**Re: Construction Storm Water Inspection at Flying Horse Farms / Morrow County
Permit Number 4GC02861*AG**

This letter is written in follow-up to a construction storm water inspection conducted by Stephen Riley and Megan Reising of Ohio EPA at Flying Horse Farms located at 5200 State Route 95 Mount Gilead, Ohio on August 05, 2010. The purpose of the inspection was to evaluate compliance with the General Storm Water Permit Associated with Construction Activities. The following was noted:

Figure 1: Concrete outpouring lacking confining boundaries

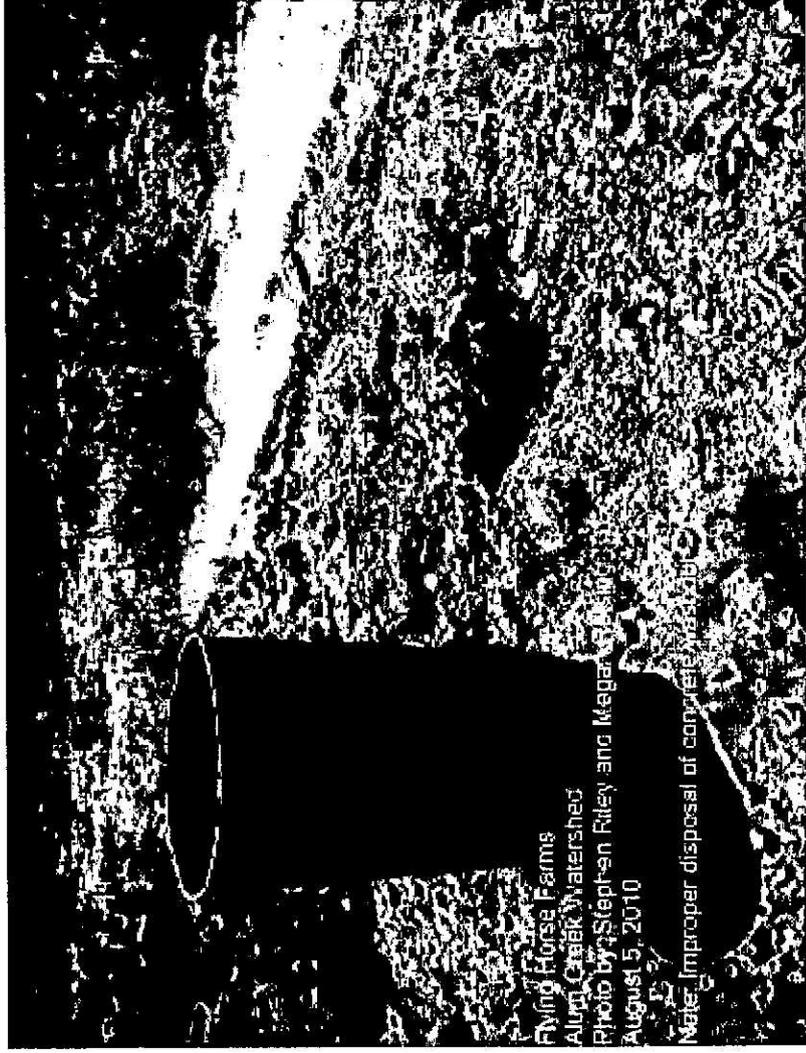
- Our staff observed an area of concrete disposal that lacked proper containment (Figure 1). If future onsite disposal is required, containment measures such as a pit impoundment is expected.
